OM Limited Partnership

Response to Interrogatory by
Board Staff

Staff-7 Ref: OMLP Application, Site Plan DWG SP 2

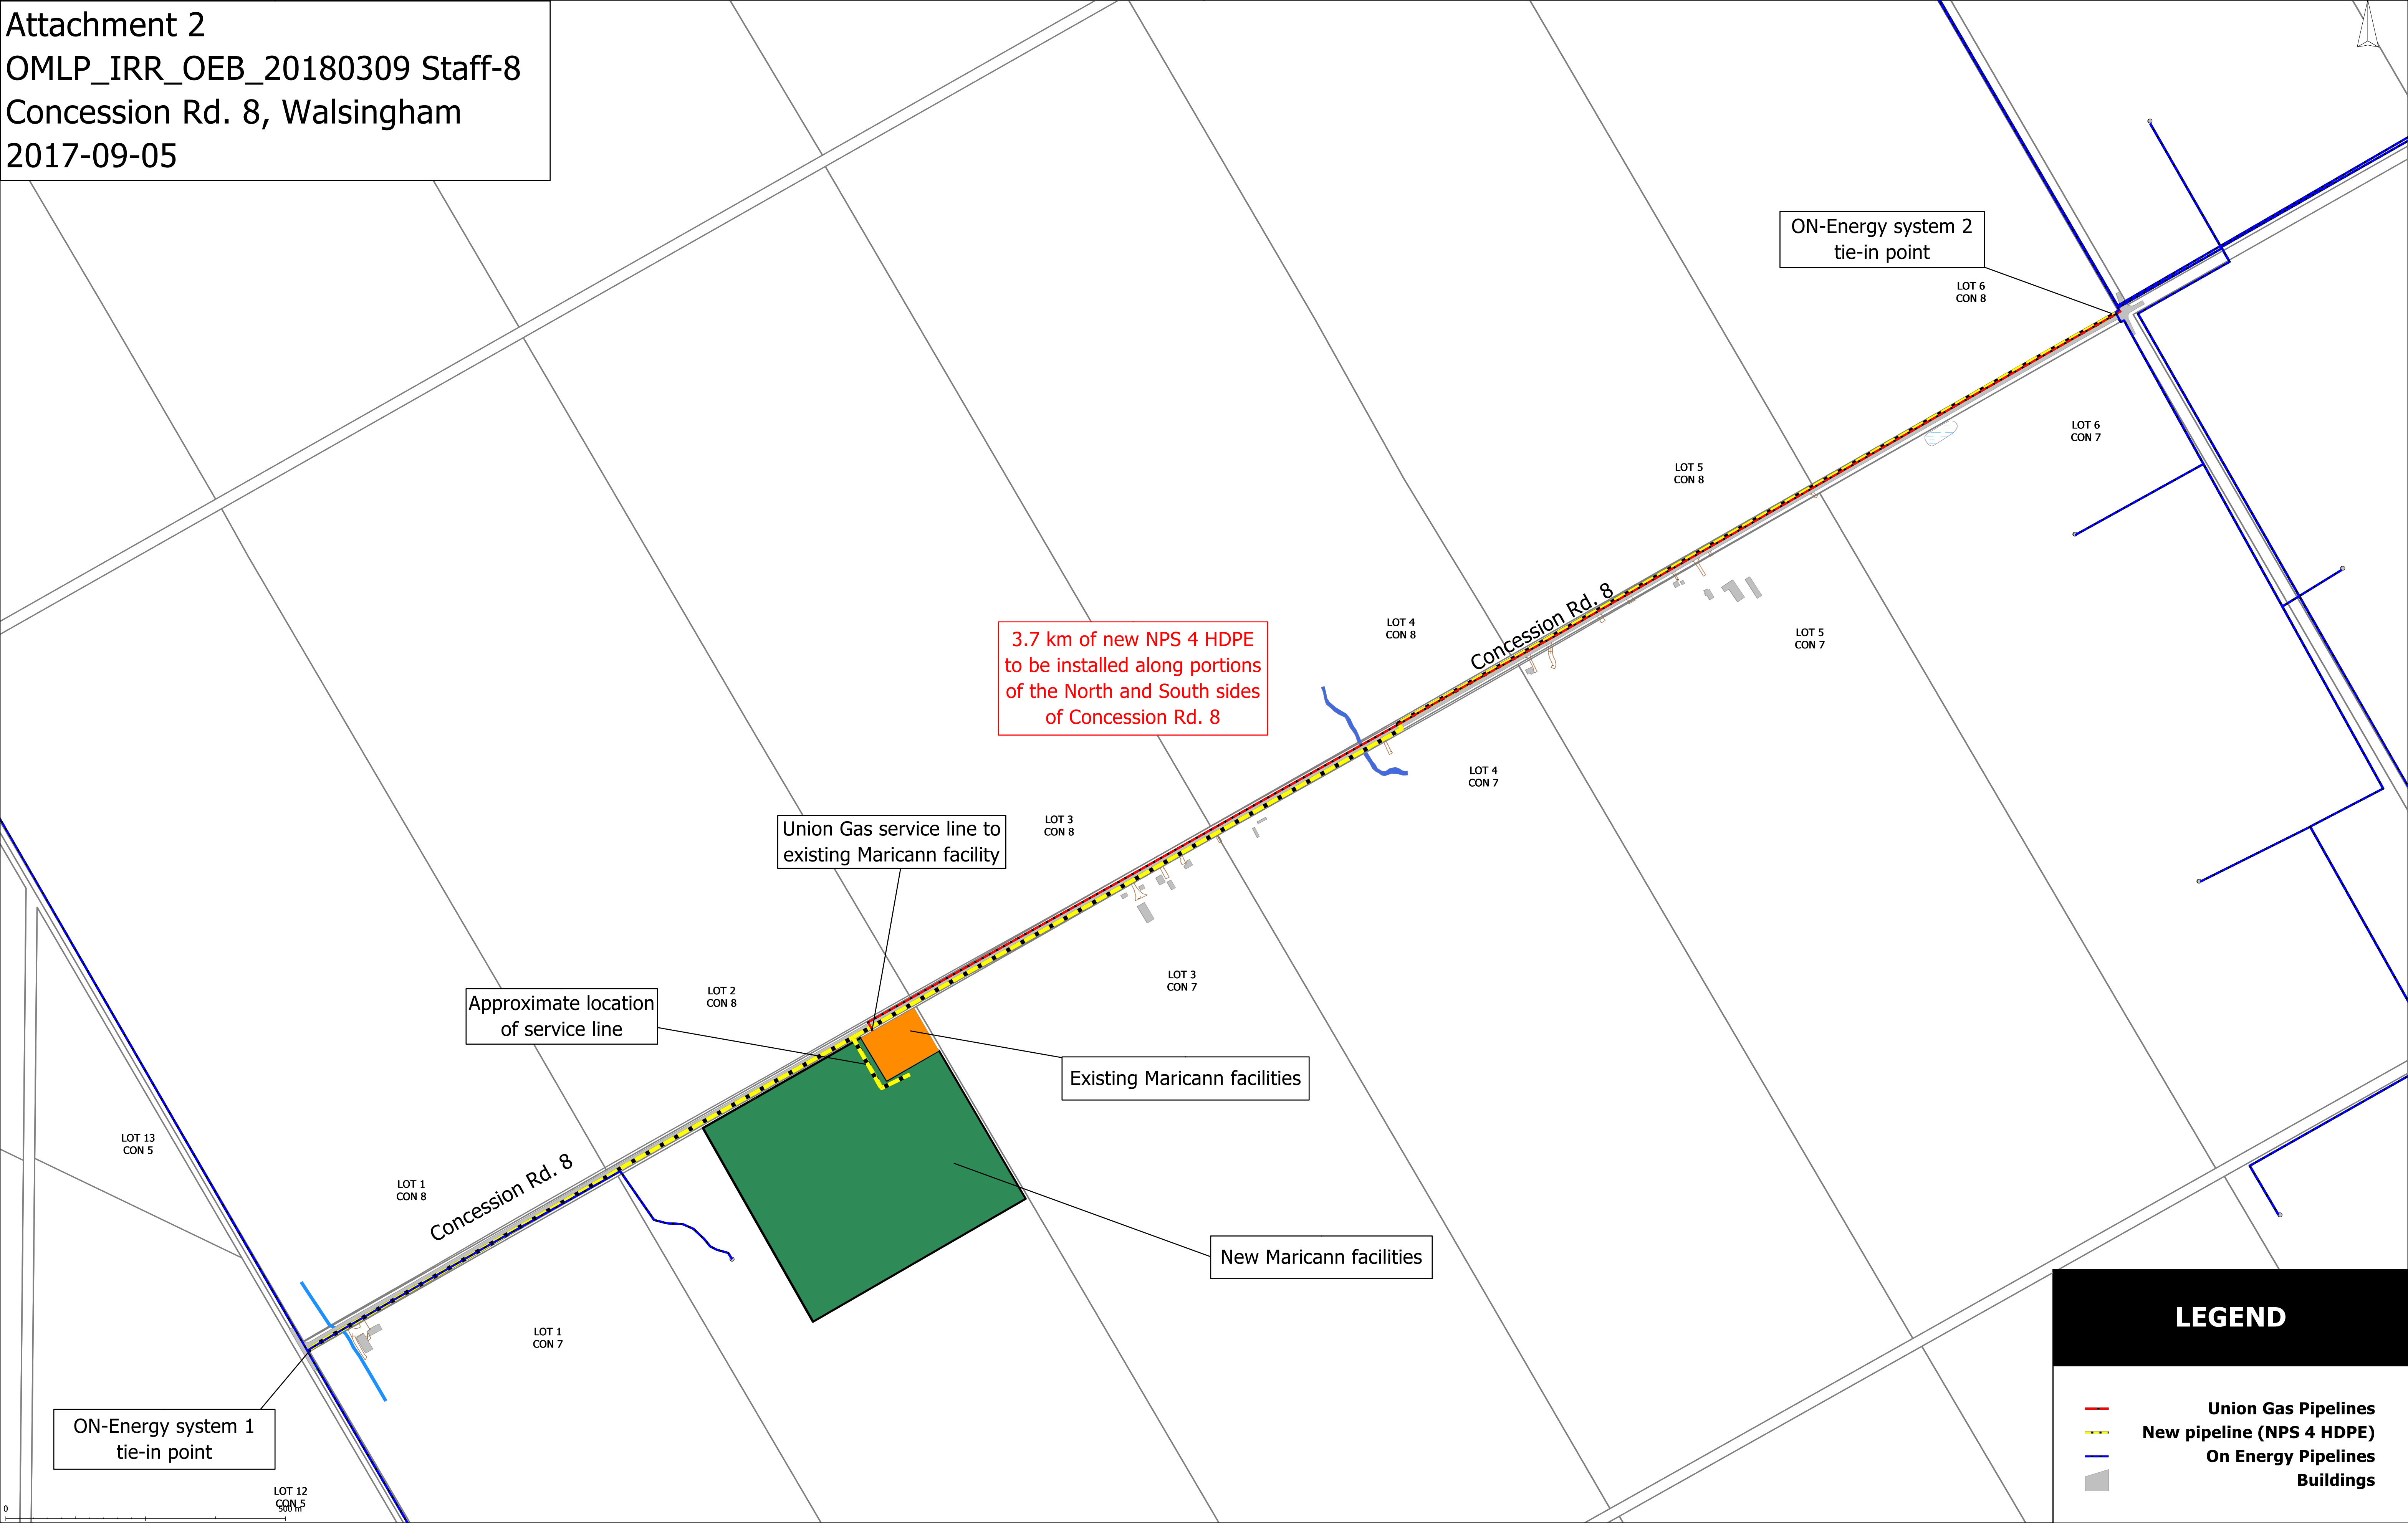
Please provide a version of Site Plan SP 2 that clearly shows the proposed tie-in system complete with offsets from major features (e.g., edge of asphalt County Road 8, Maricann driveway, building lines, etc.), the NPS 4 HDPE pipeline on County Road 8, and the service pipeline connecting the two.

Please see attached site plan (Attachment 1).
